WOLF CREEK NUCLEAR OPERATING CORPORATION

ET 10-0005

Subject: Docket No. 50-482: Response to Request for Additional Information Related to License Amendment Request for Deviation from Fire Protection Program Requirements

REQUEST FOR ADDITIONAL INFORMATION
DEVIATION FROM FIRE PROTECTION PROGRAM REQUIREMENTS
WOLF CREEK NUCLEAR OPERATING CORPORATION
WOLF CREEK GENERATING STATION
DOCKET NO. 50-482

Attachment D

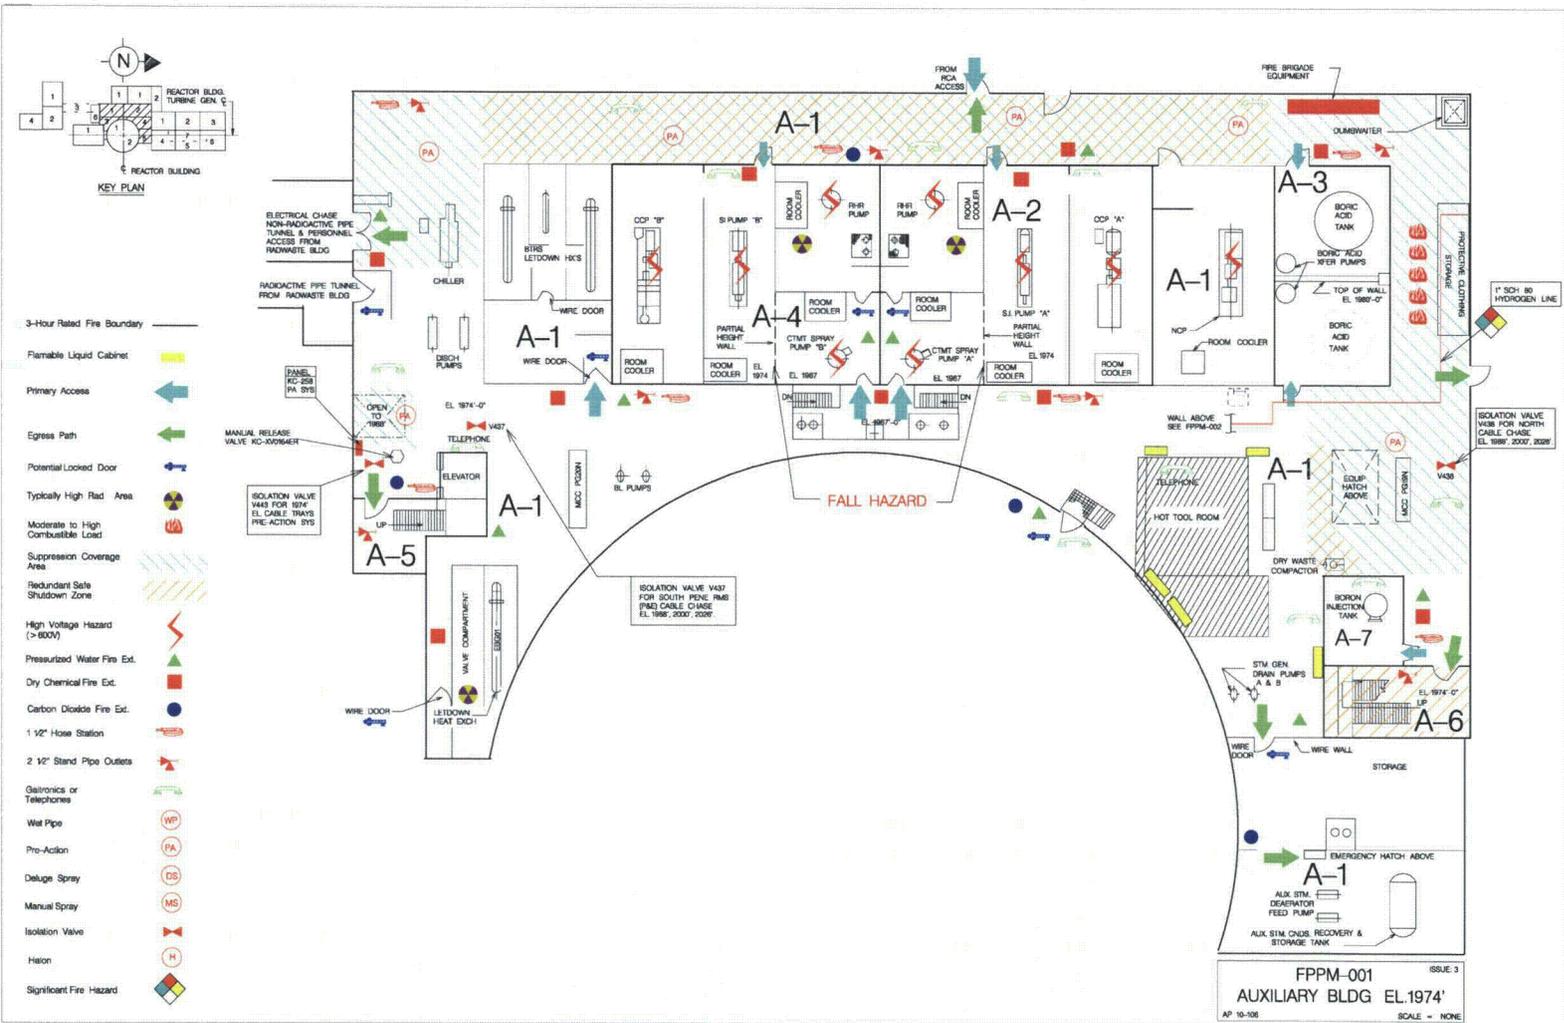
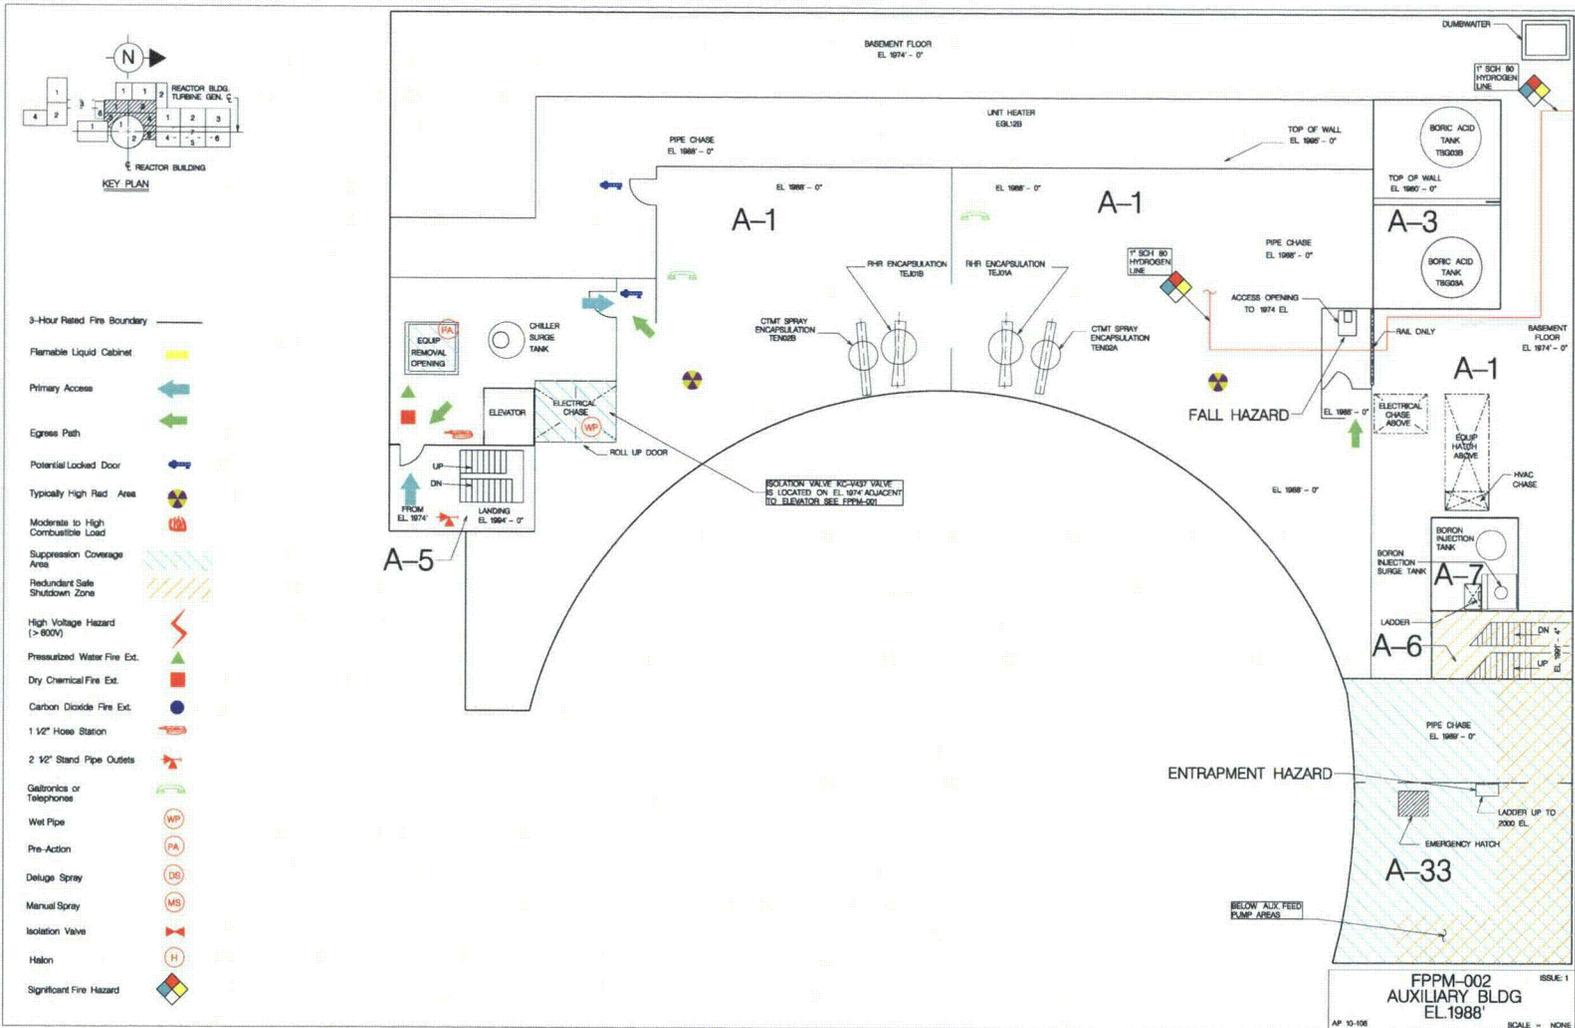
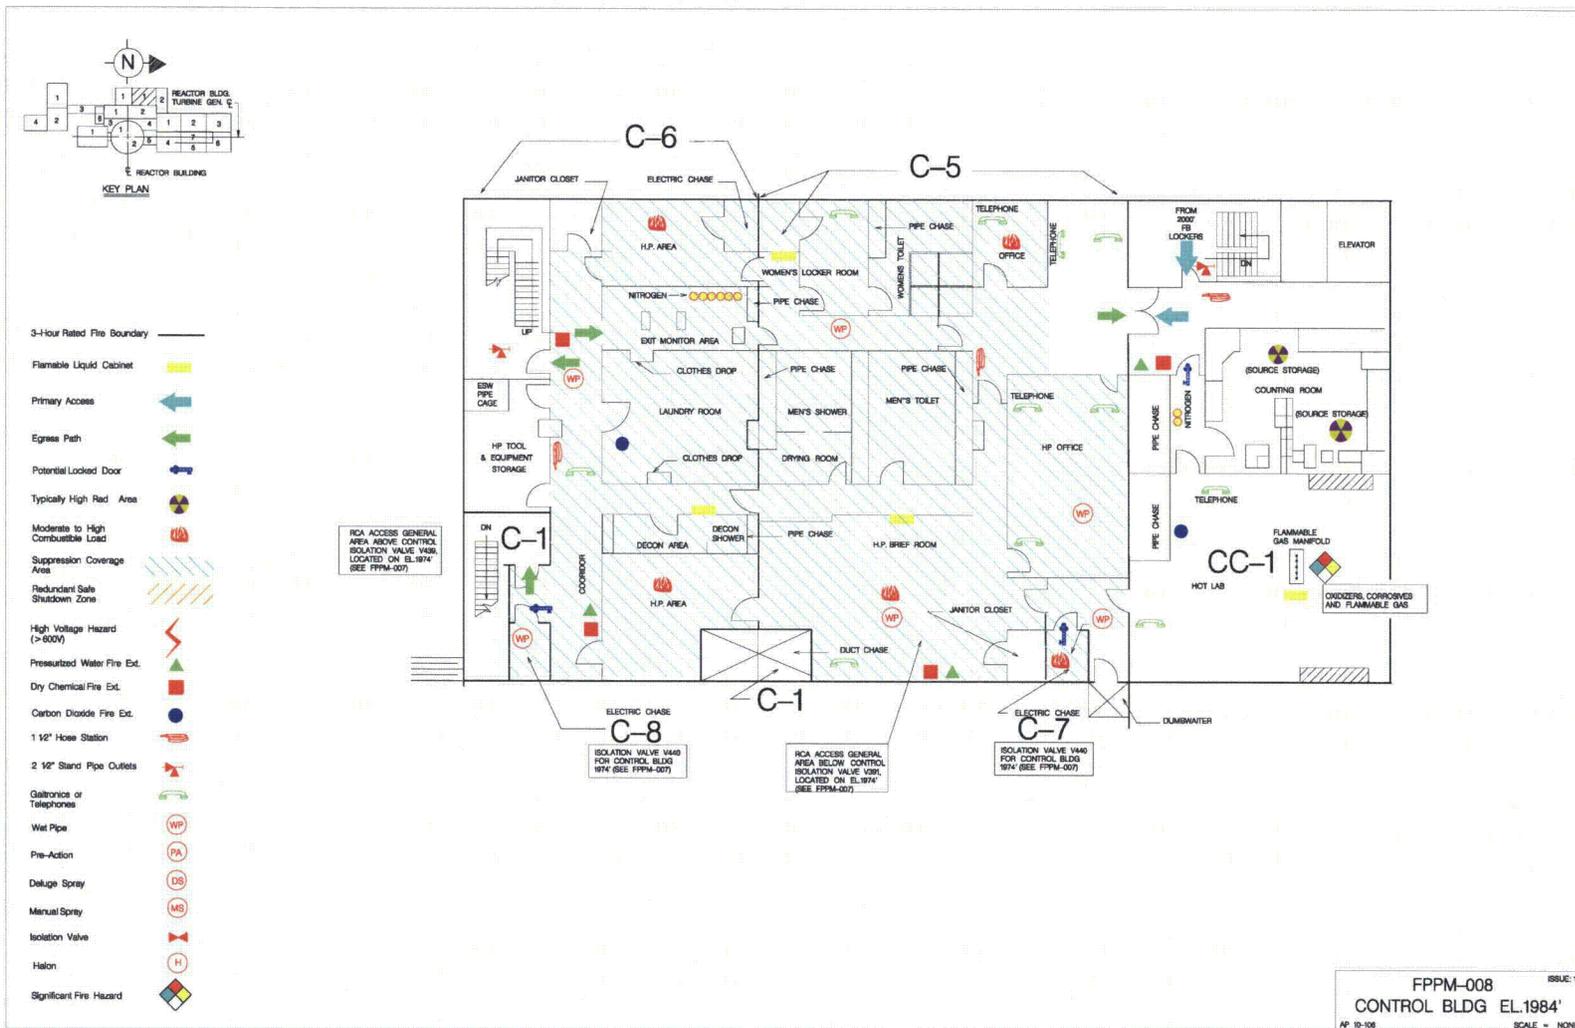
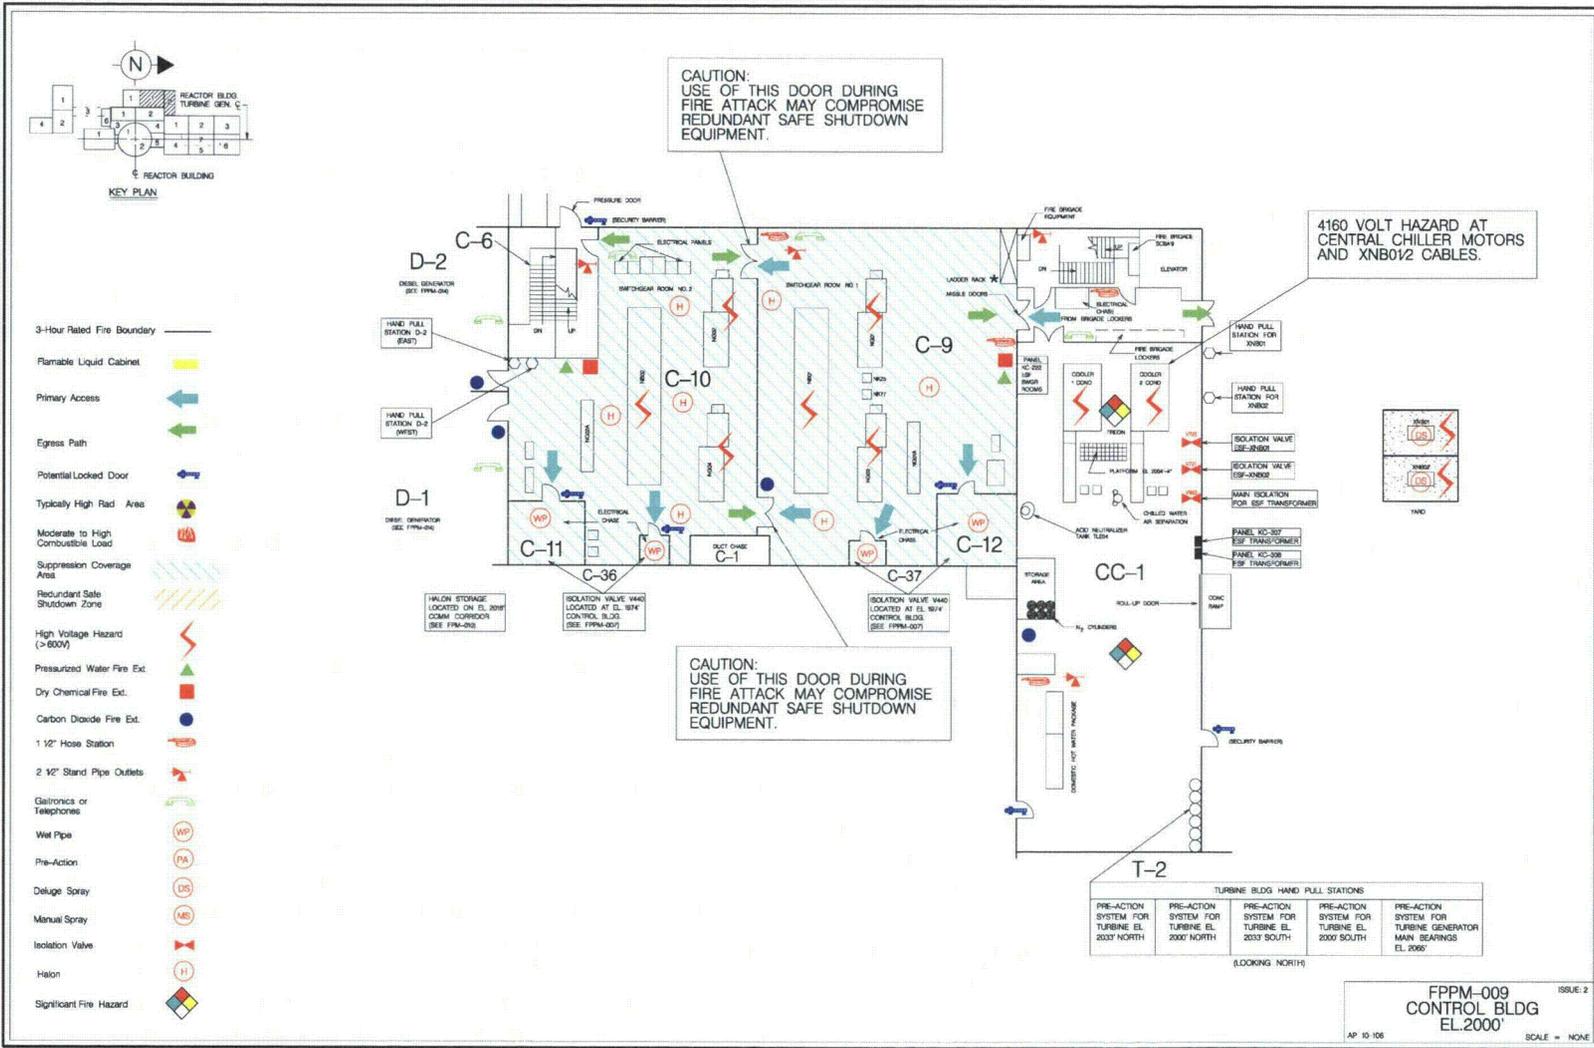
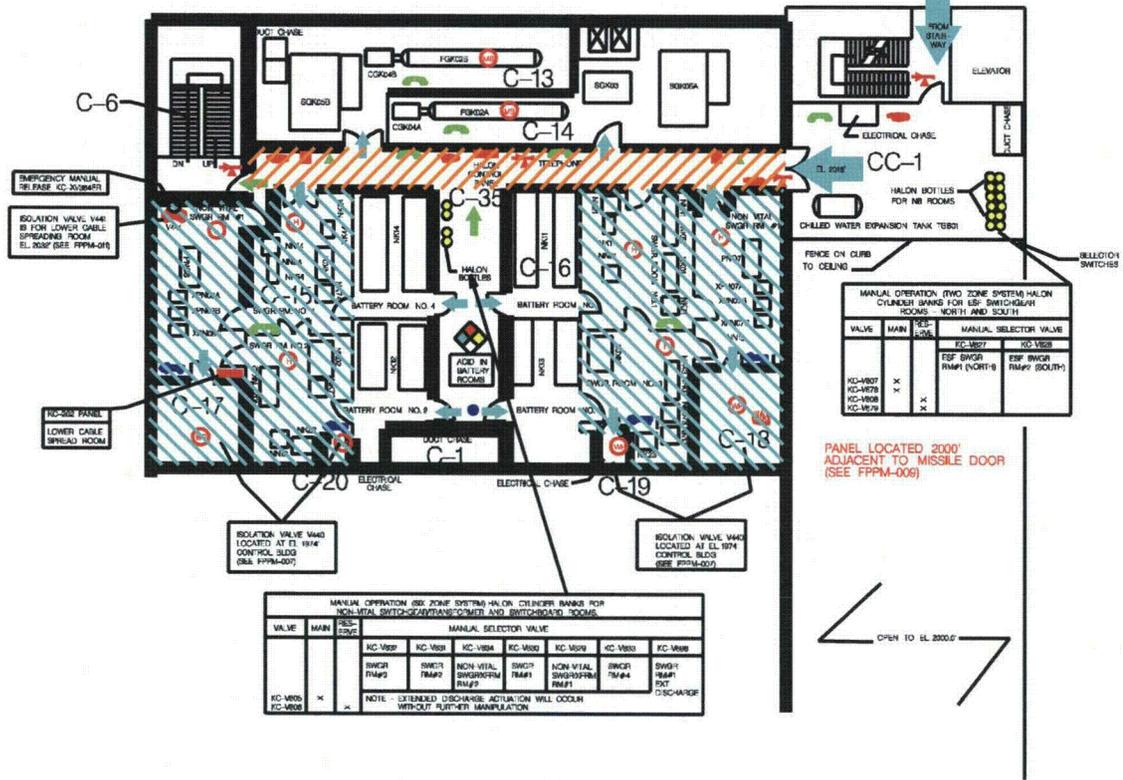
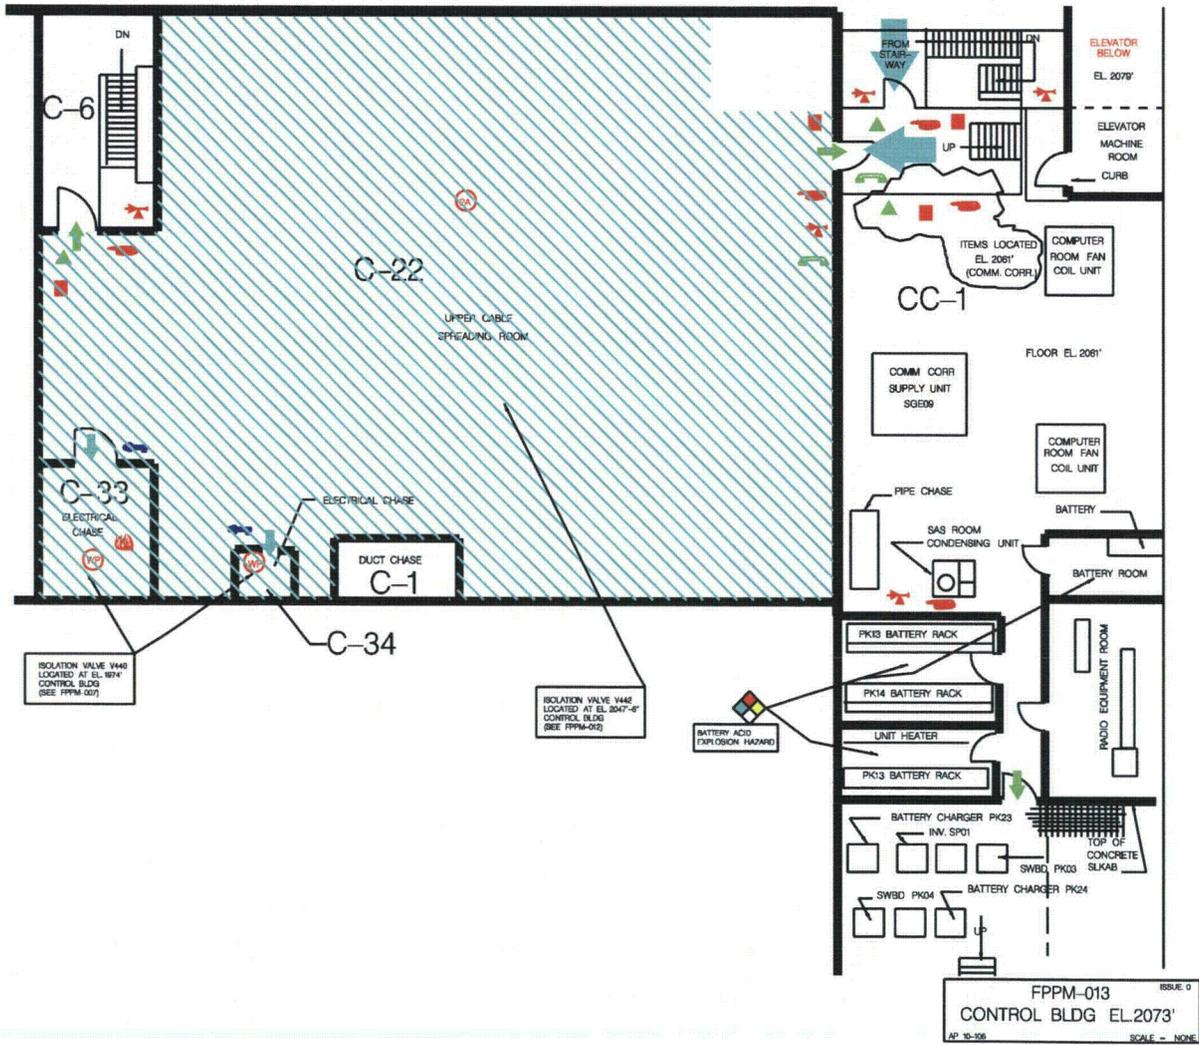
RAI-04.1: Please provide critical details or assumptions regarding the *in-situ* and transient fire hazards that could threaten redundant equipment for each fire area included in the requests. This information may include, but is not limited to:

- The number, type, and location of potential ignition sources,
- The number and types of equipment that may exhibit high-energy arcing faults, and the relationship between this equipment and any secondary combustibles,
- The quantity of cables and other secondary combustibles and their relationship to potential ignition sources,
- The cable type (e.g., thermoplastic or thermoset); if thermoplastic cables are used, please provide a discussion of self-ignited cable fires,
- Ratings for cables (e.g., Institute of Electrical and Electronics Engineers (IEEE) 383, etc.); if not rated, please justify why fire spread would be assumed to be slow,

Section 8.X.1 of WIP-E-1F9900-004-A-1 was revised for each fire area to identify approximate room dimensions. Room height is also identified in Attachment B1 of WIP-E-1F9900-004-A-1. Attachment D was added to WIP-E-1F9900-004-A-1, to provide a general plan view for each fire area.
